### **BAY AQUATIC BENEFICIAL USE SITES**

#### **GALVESTON BAY, TEXAS**

RE: Antiquities Permit 31570; Archaeological Assessment of the Bay Aquatic Beneficial Use Sites Project; request for 2nd amendment to revise the survey area and add probing of selected magnetic anomalies

## CHANGES TO THE SCOPE OF WORK

**Figure 2: Proposed Amendment 2 Survey Area (combined shaded areas; blue is survey completed; yellow is additional survey proposed) and magnetic anomalies to be probed (red); Amendment 1 Area is cross hatched**

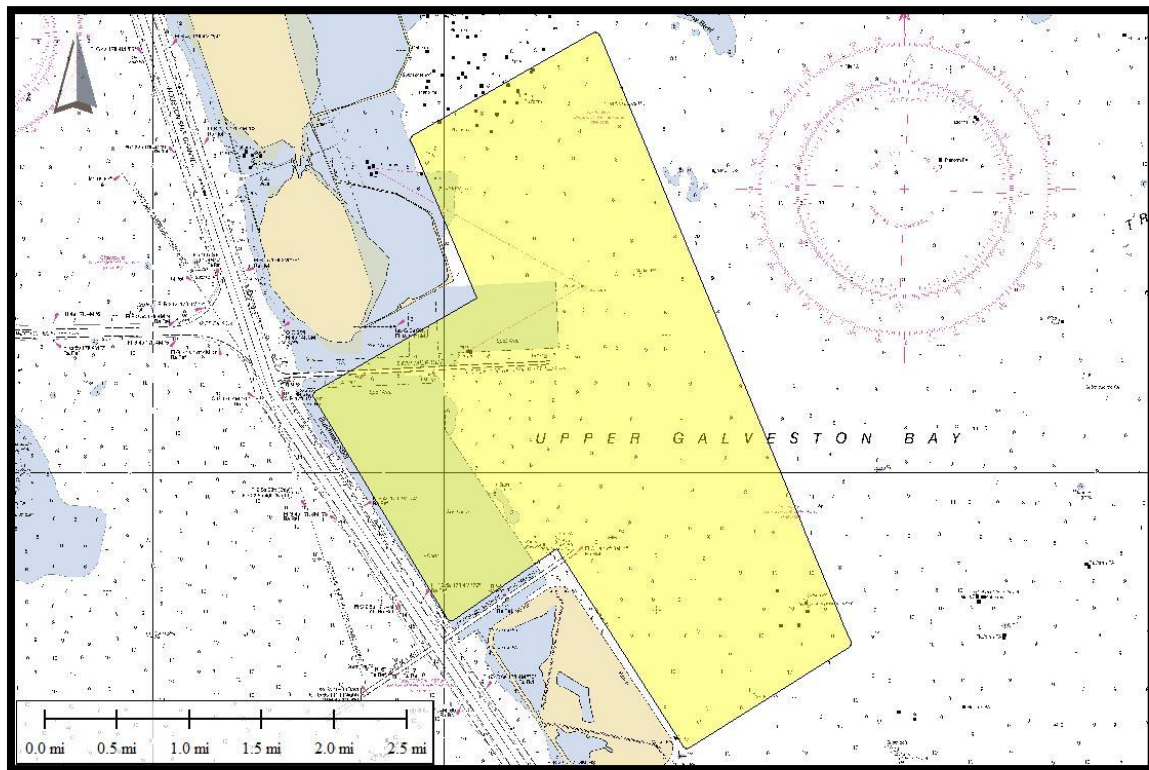
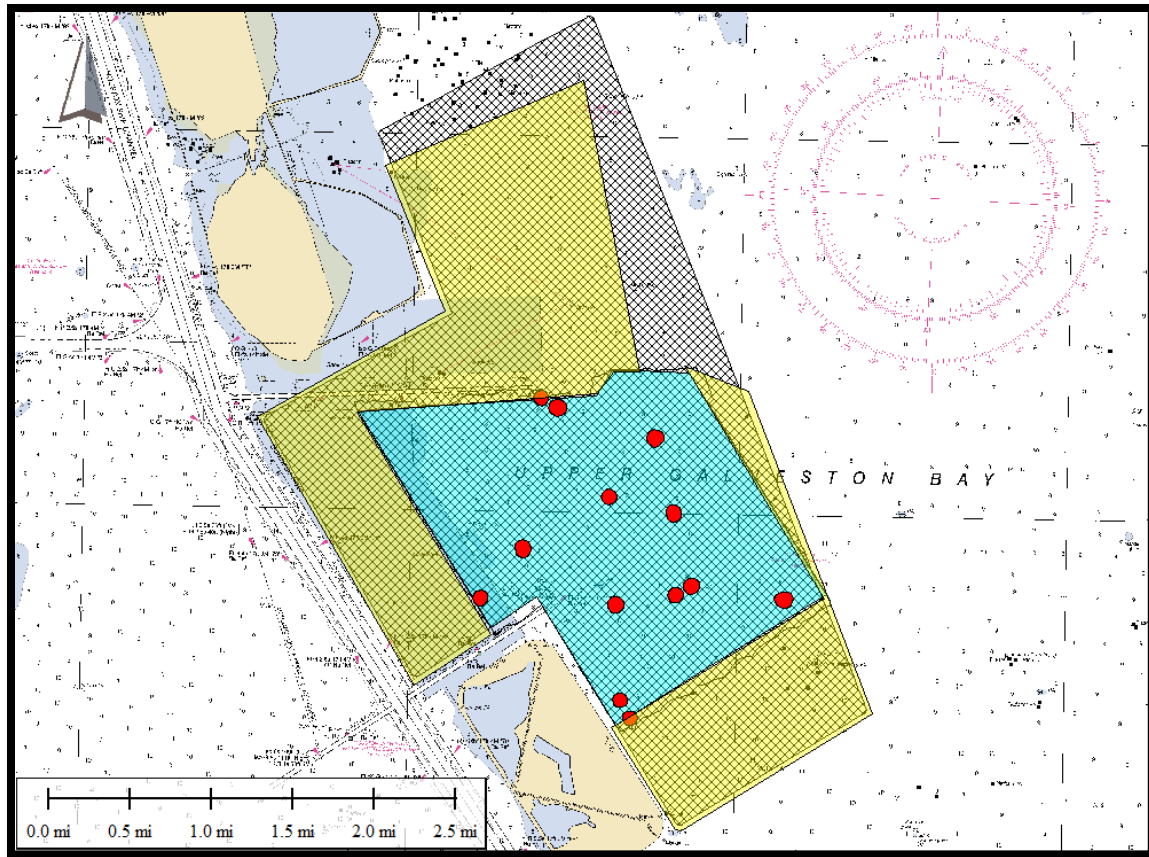
The next phase of fieldwork would involve archaeological survey of additional BABUS areas, encompassing 2,977 acres (Figure 2, shaded yellow). The survey includes 50 meters (164 feet) beyond any potential seafloor disturbances. Probing of selected magnetic anomalies, recommended for archaeological avoidance, is proposed to follow the survey planned under Amendment 2. A total of 13 such anomalies (Figure 2, shaded red) were discovered during survey of in March of 2024. Discovery of additional anomalies, requiring probing, is anticipated during the next phase of survey. The purpose of probing would be to determine the presence/absence of buried shipwrecks.
